Placer County Office of Education

Office Building Tenant Improvements, Annex Building Alterations, & Site Improvements @ Various Sites

ADDENDUM NO. 2

Friday, September 1, 2023

1 E1.01 SITE PLAN - ELECTRICAL

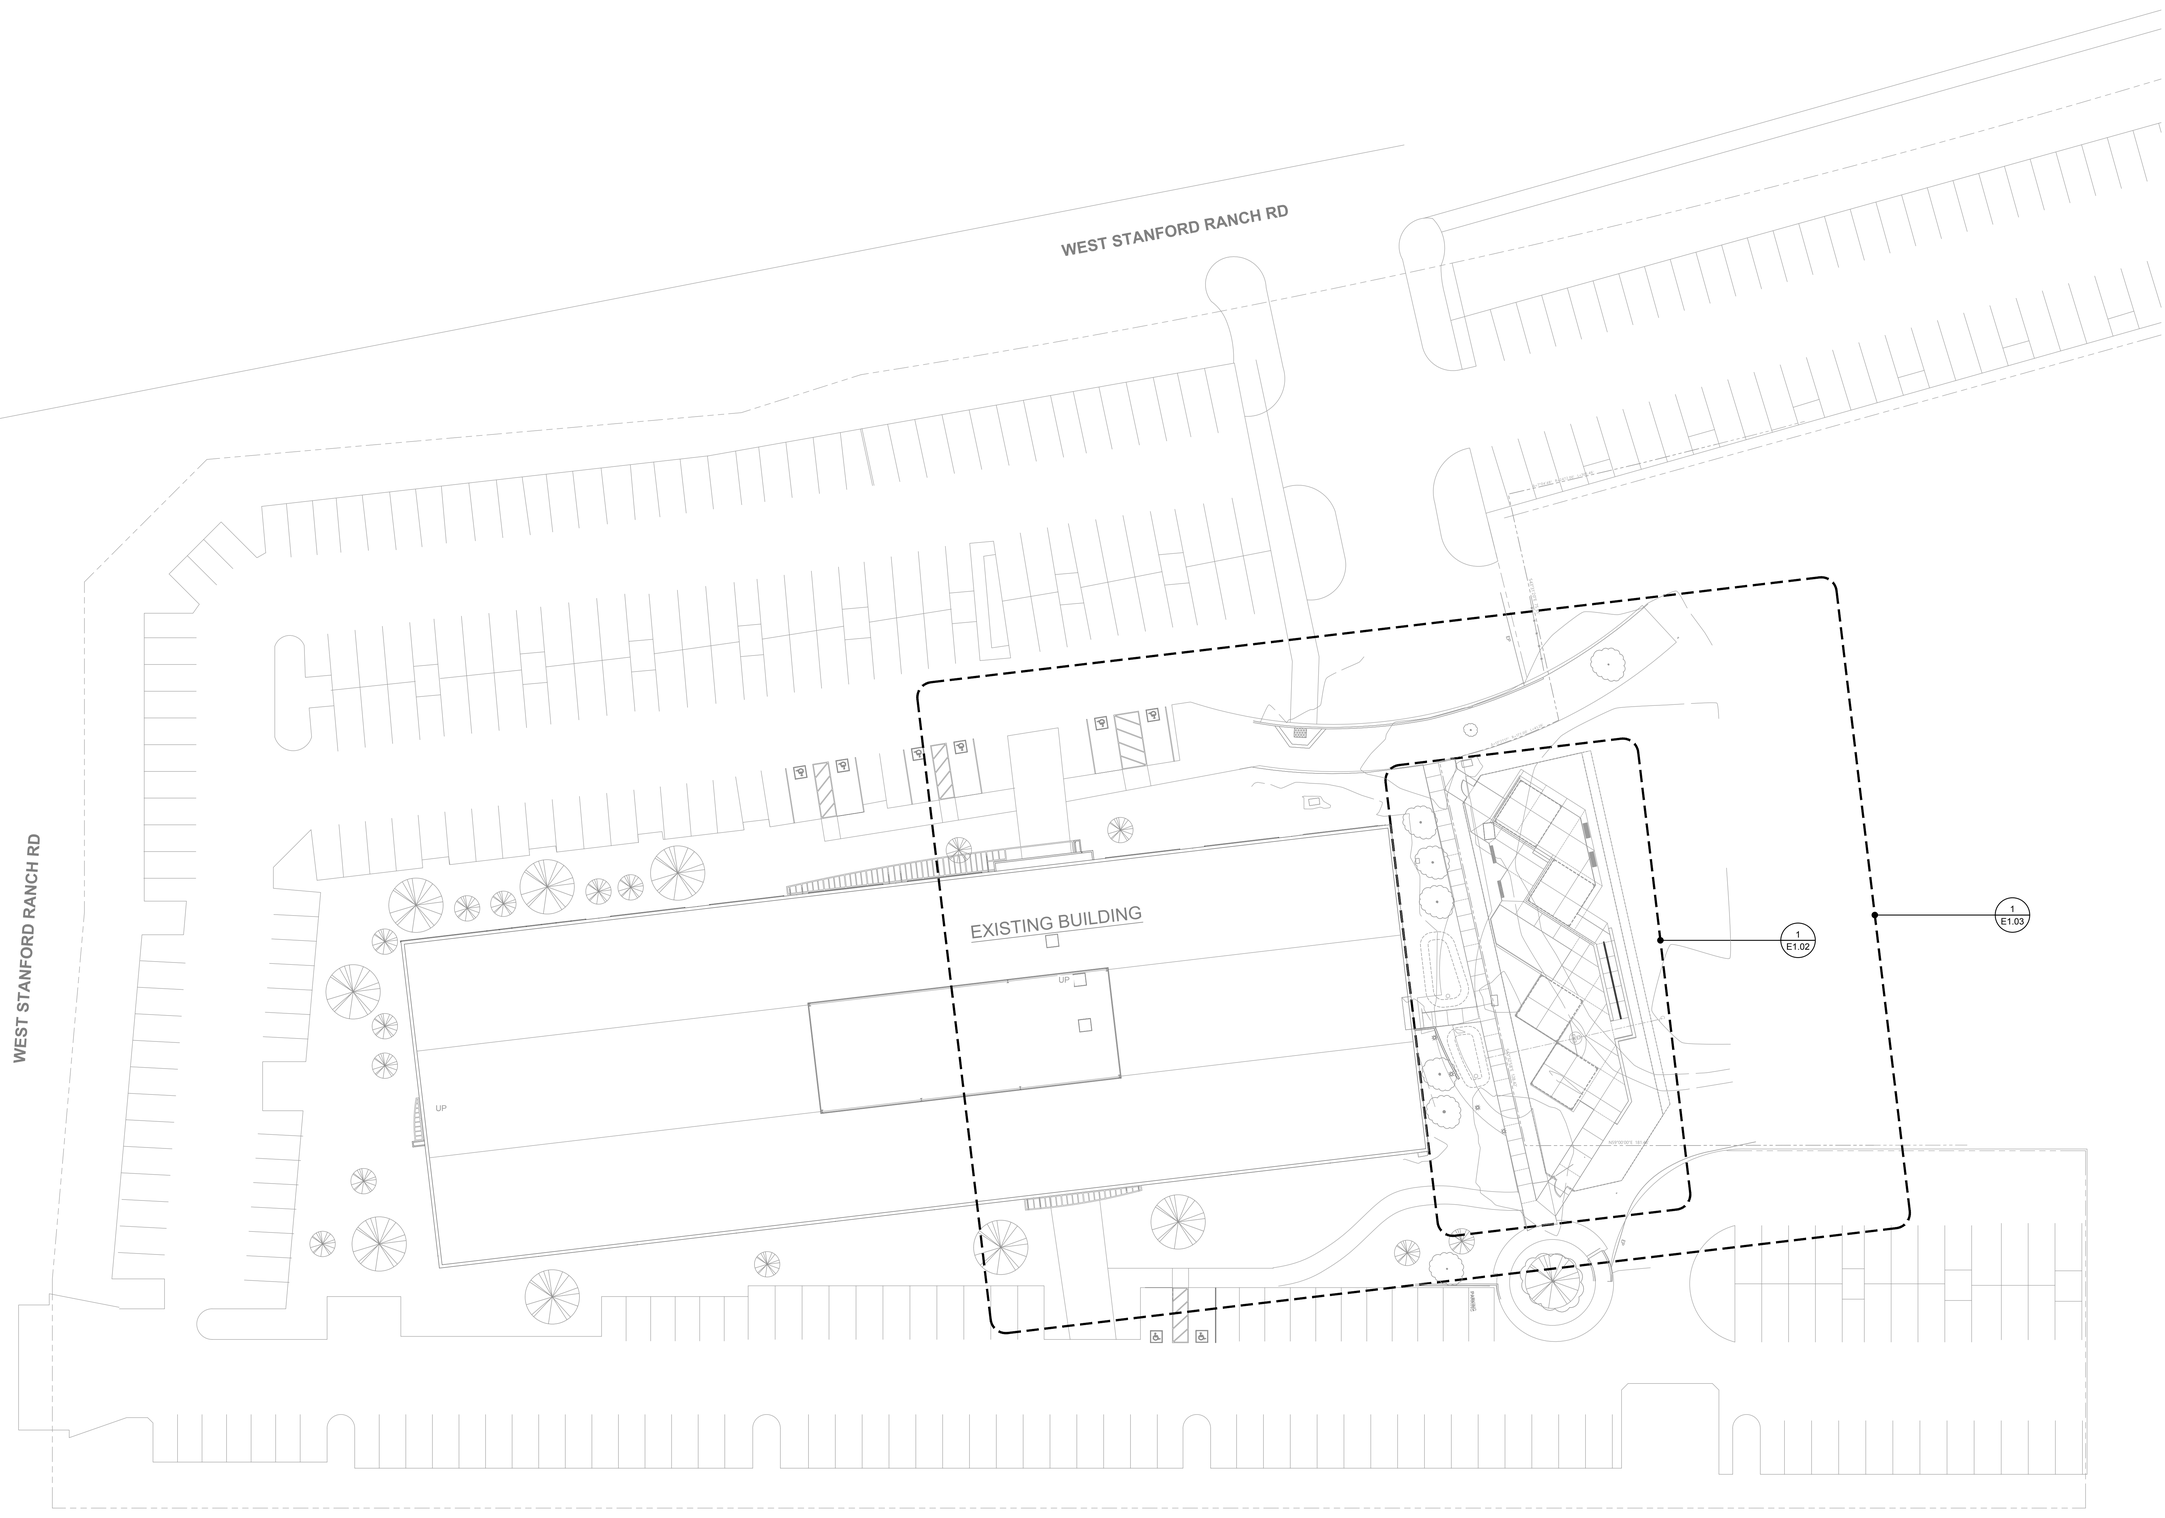
A. **ADD** sheet in its entirety for site electrical work. **See attached 'SHEET E1.01'.**

1 / E1.02 ENLARGED SITE PLAN - ELECTRICAL

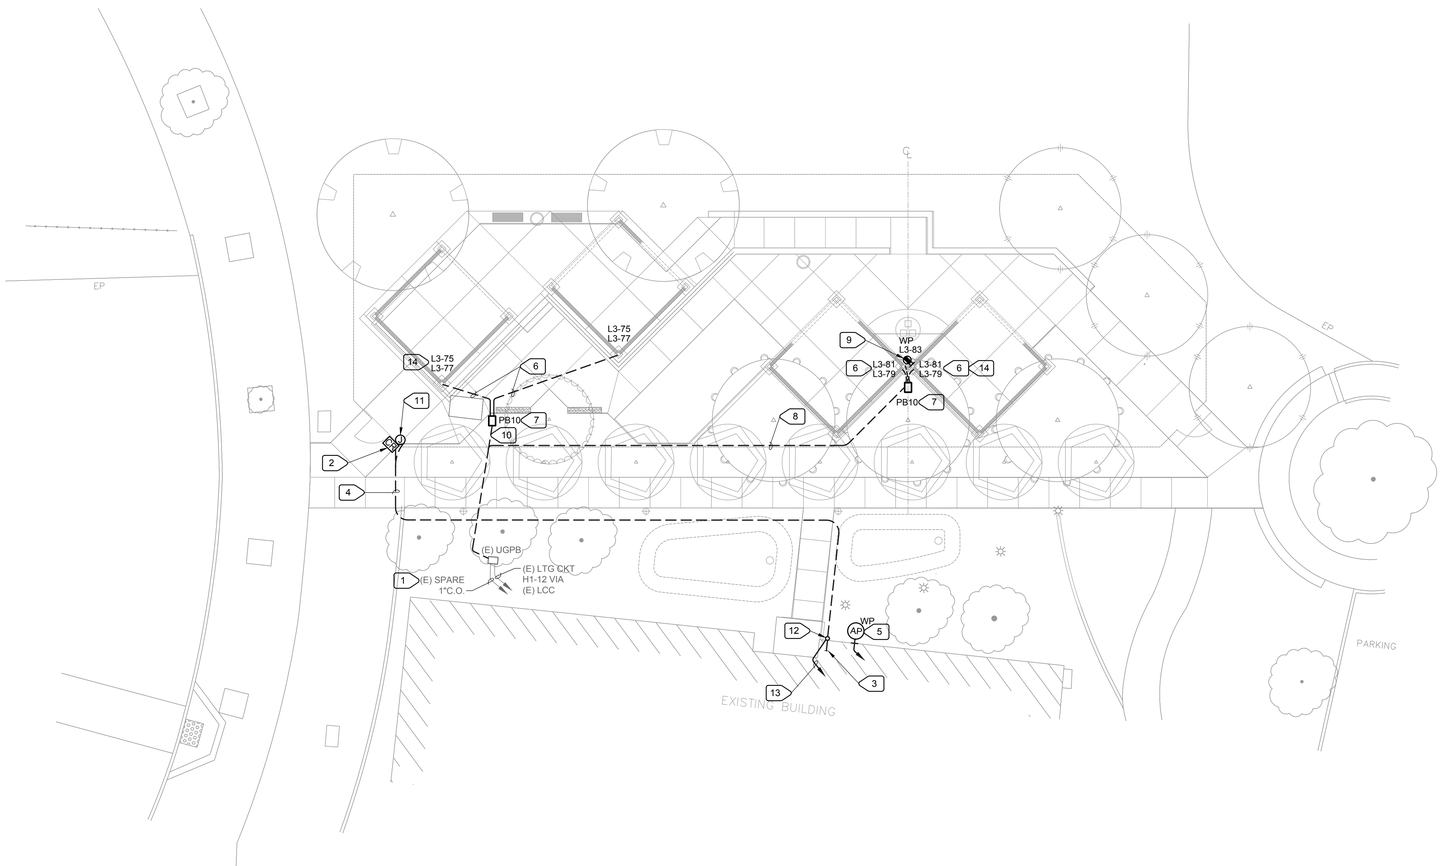
A. **ADD** sheet in its entirety for site electrical work. **See attached 'SHEET E1.02'.**

1 E2.01 — FIRST FLOOR PARTIAL PLAN - DEMOLITION - WEST - LIGHTING

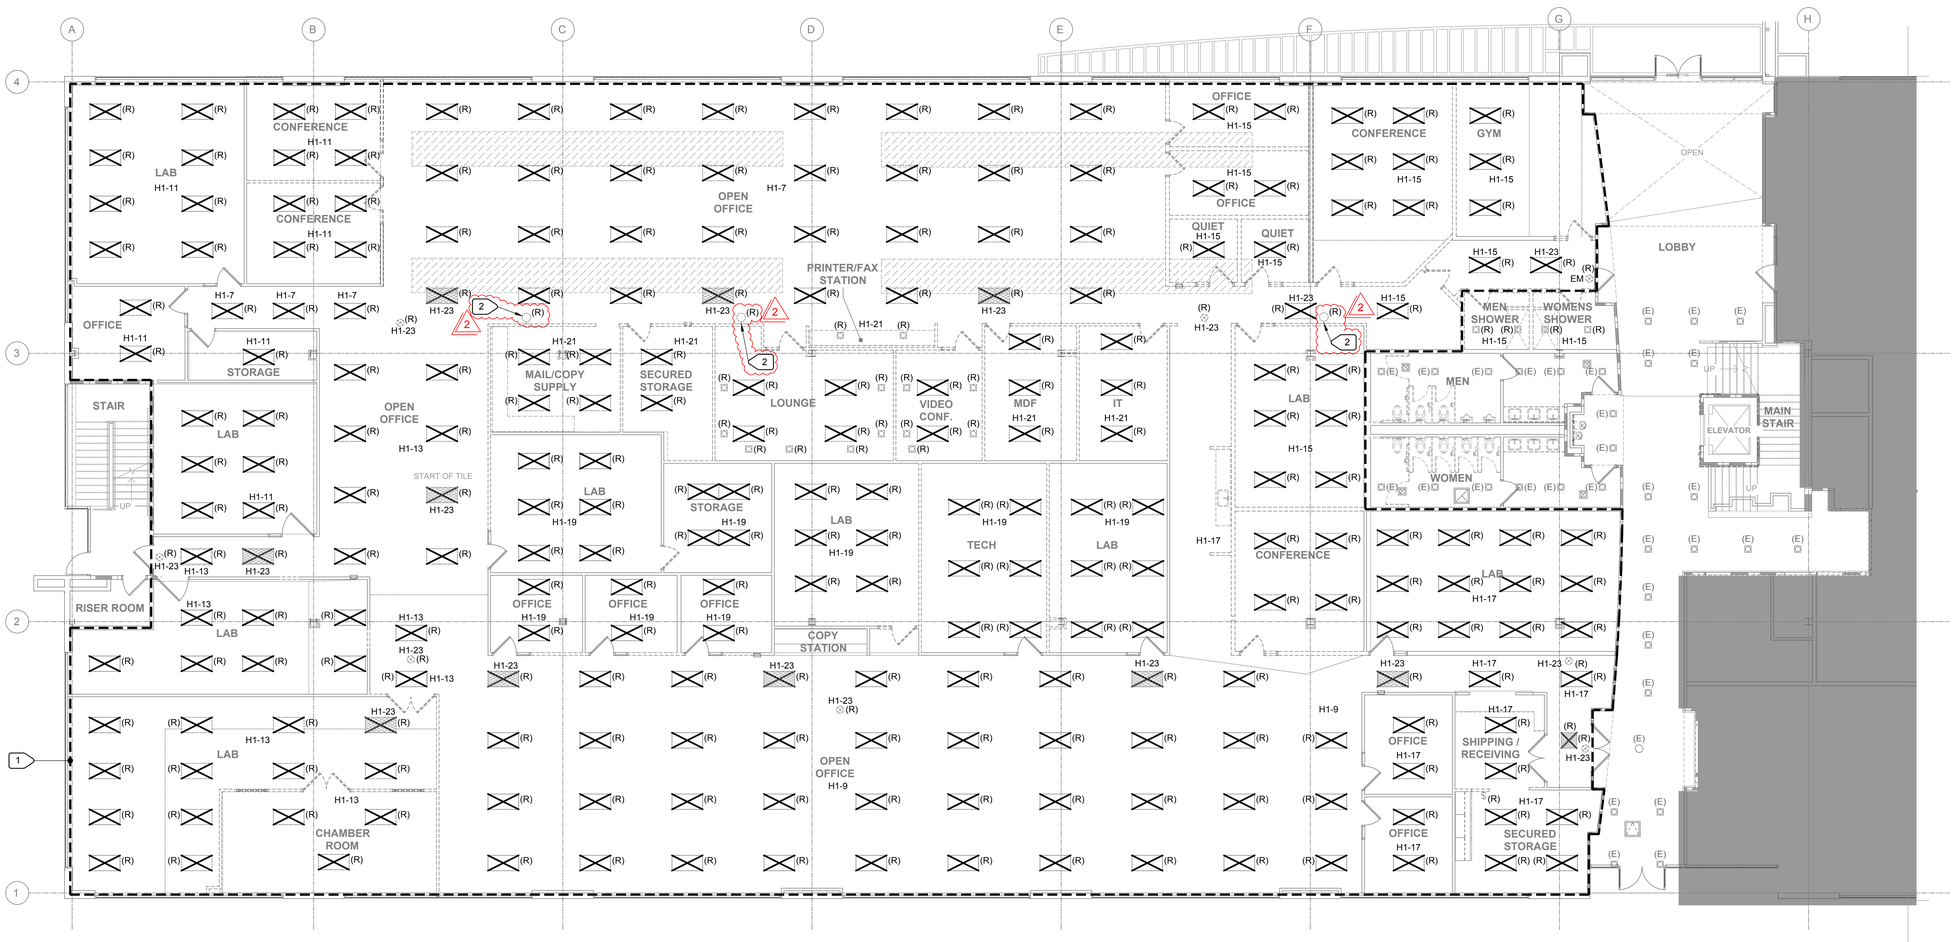
A. **REVISED** extent of lighting demo. **See attached 'SHEET E2.01'.**

1 E2.02 SECOND FLOOR PARTIAL PLAN - DEMOLITION - WEST - LIGHTING

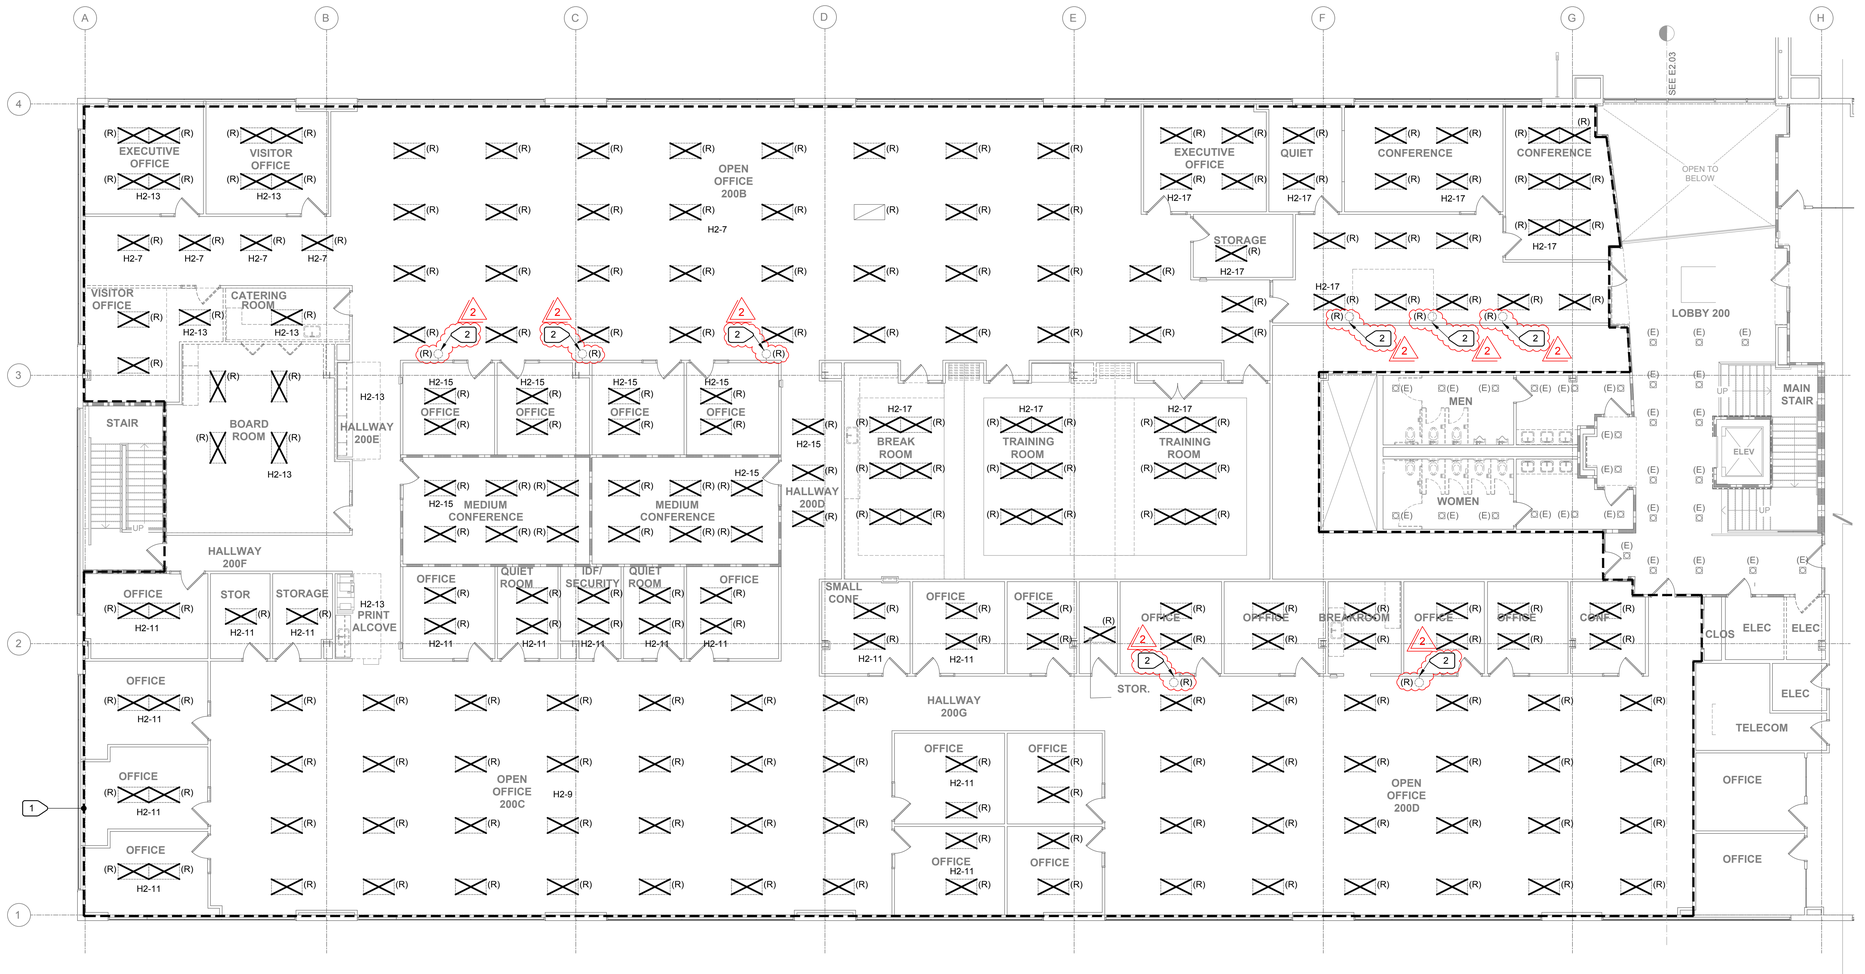
A. **REVISED** extent of lighting demo. **See attached 'SHEET E2.02'.**

1 / E2.03 SECOND FLOOR PARTIAL PLAN - DEMOLITION - EAST - LIGHTING

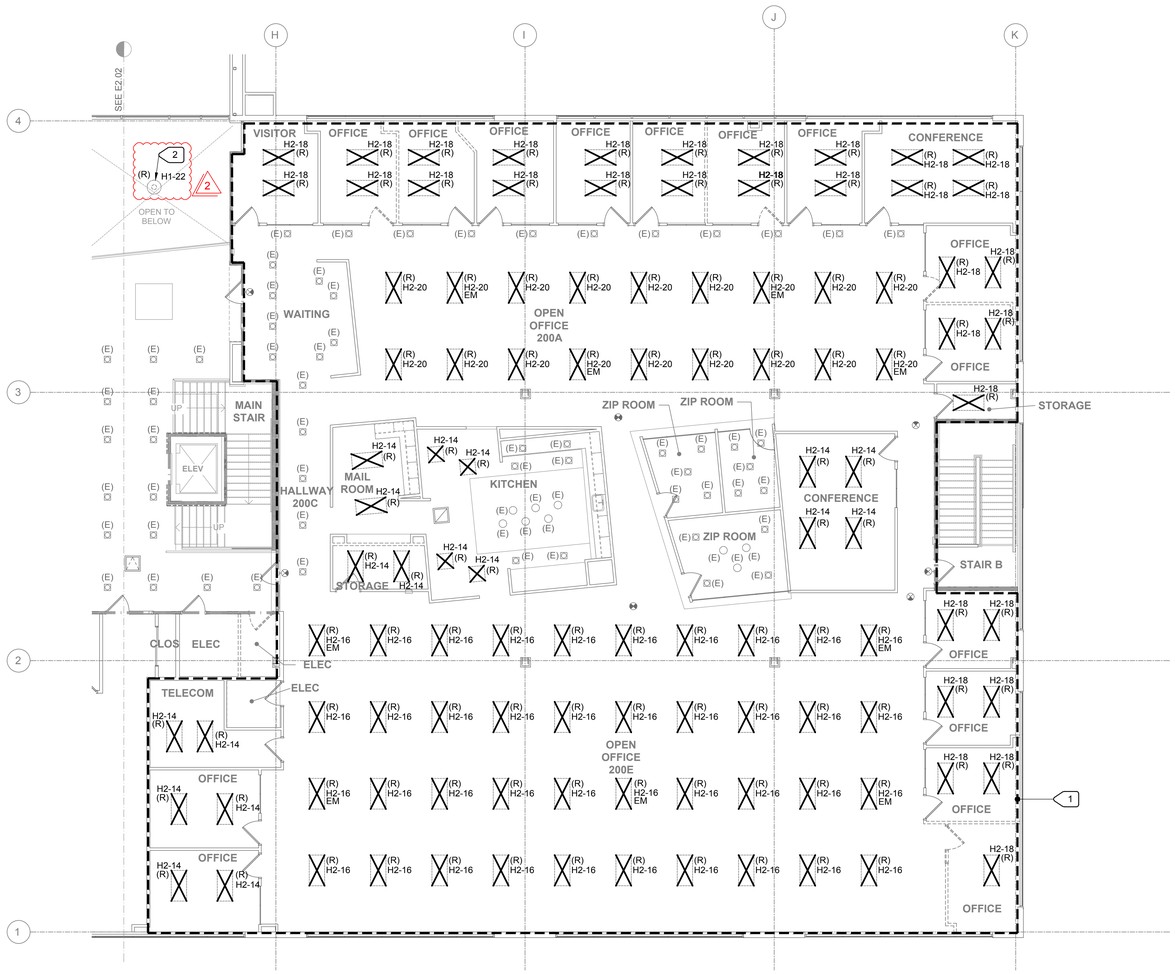
A. **REVISED** extent of lighting demo. **See attached 'SHEET E2.03'.**

1 / E2.04 FIRST FLOOR PARTIAL PLAN - REMODEL - WEST - LIGHTING

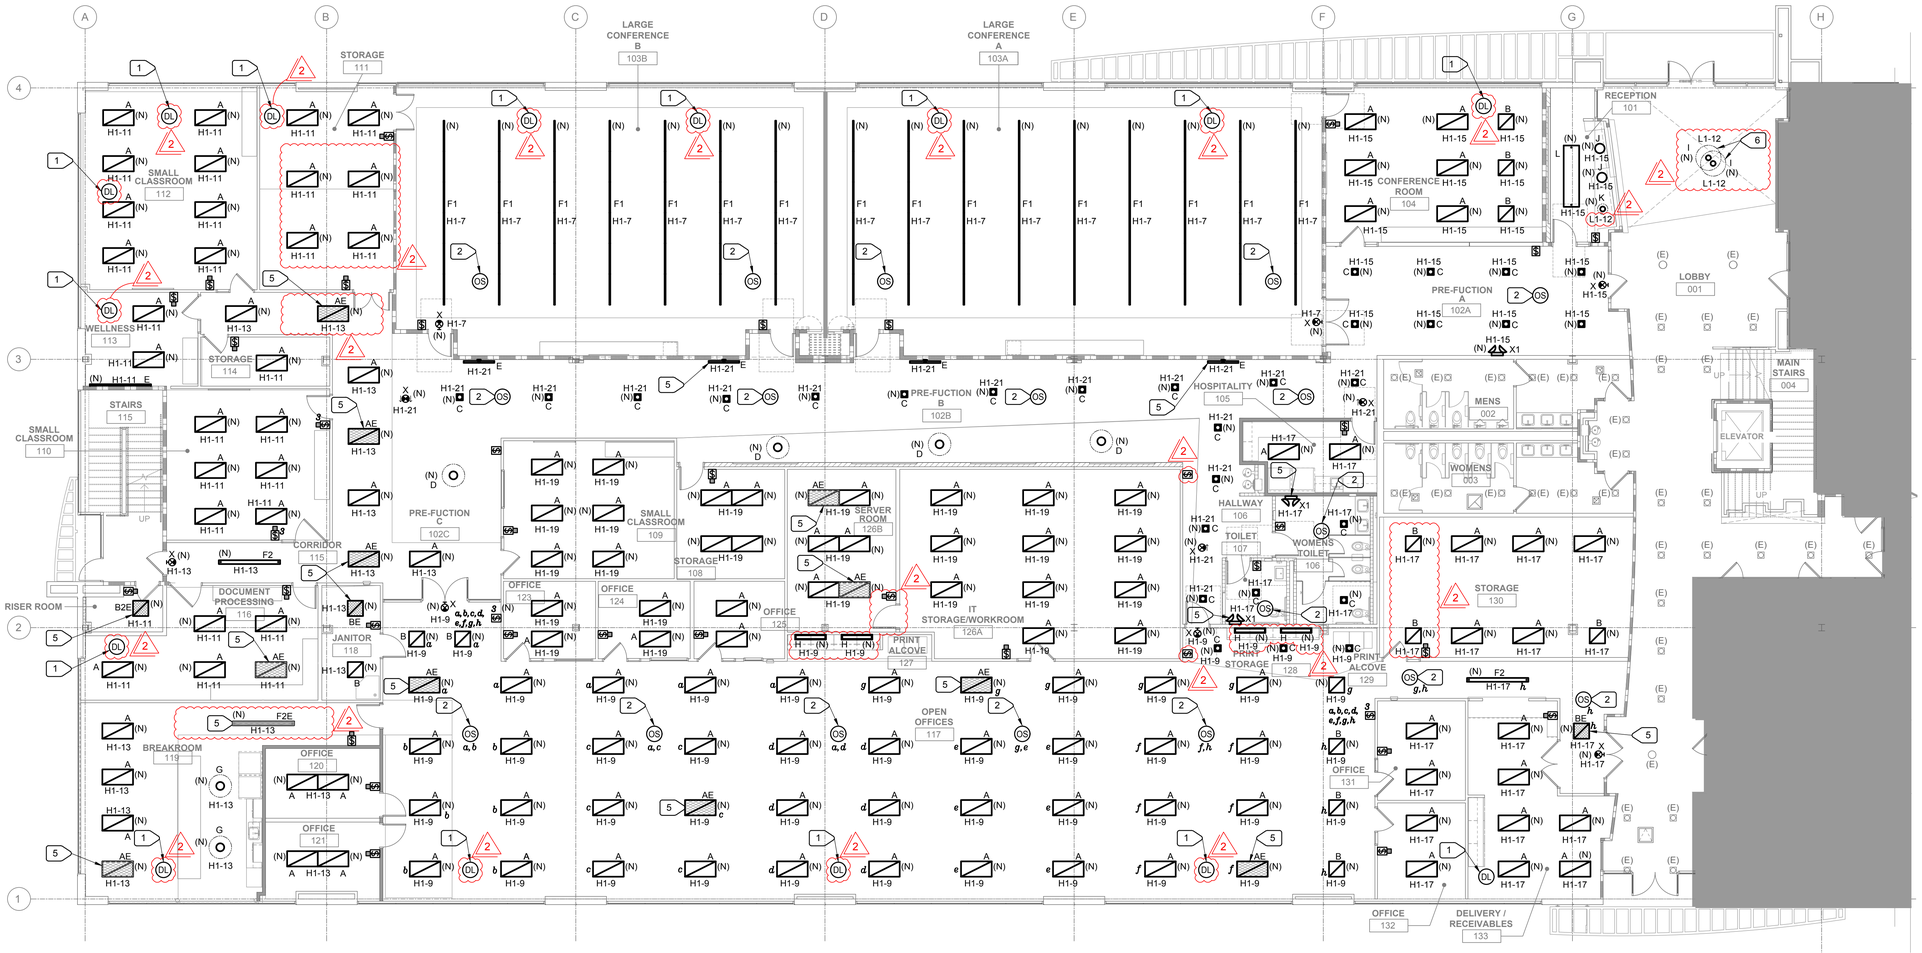
A. **REVISED** extent of new lighting. **See attached 'SHEET E2.04'.**
